**FORMER HOFFMAN BRICKWORKS, 72 - 106 DAWSON STREET,  
BRUNSWICK**

RFI Response - P31711 17<sup>th</sup> July 2020 & 22<sup>nd</sup> July 2020

**In relation to Demolition of the Brick Pressing Shed (Buildings 5 and 6) and  
construction of a new building including an interpretation centre.**

*Victorian Heritage Register Number: H 0703 Date: 2 October, 2020*

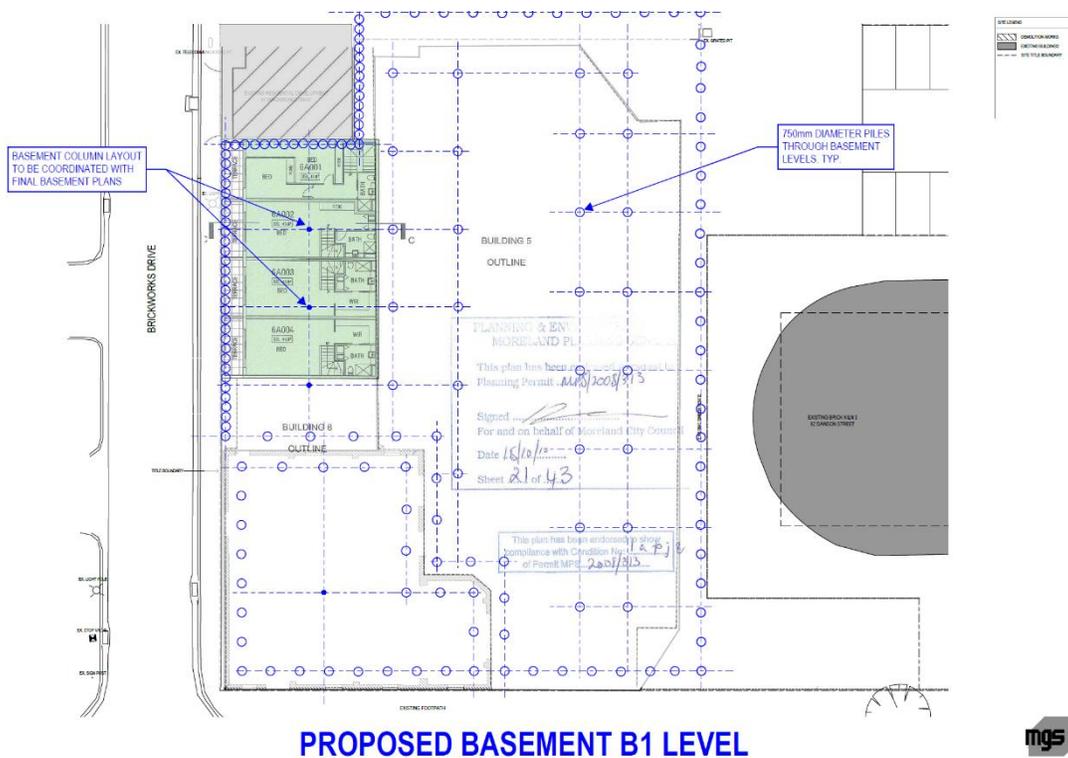
After the removal of all primary sources of pollution (such as tanks and pits, or pollution sources within machines or equipment – such as petrol, oil, asbestos etc), the Auditor and EPA verified SAQP document requires 21 test pits (19 target and two grid) and 9 wells (30 locations) across the Buildings 5 and 6 area. The test pits are to be completed up to 3-4 m depth, but if contamination is identified (odours, staining, elevated PID readings) as expected then deeper test pits will be required, as vertical delineation of any contamination is necessary.

To complete these test pits with the buildings in-situ post removal of the brick pressing machines, we would need larger cuts in the concrete slabs (3.5x1.5 m) and approximately 70% of machinery cleared to allow appropriate access. Another issue is 8 test pits are required directly adjacent the site boundaries (ideally within 0.5 m). To complete these test pits and bulk out the contaminated material to 6.0 m depth would likely require a 15-17 tonne excavator (minimum) with a width of 2.8 m, height of 4.0-5.0 m, and length of 8.7 m. You would also need minimum 1.0 m clearance around the rig and access routes for OH&S.

The wells have to target to 16 m depth and use an air hammer through the rock, as such the smallest drilling rig would be a Geoprobe, image below:

We will require a minimum of 7.0 m length clearance, 4.0 m width clearance and 4.5 - 5.0 m height clearance to drill the wells.
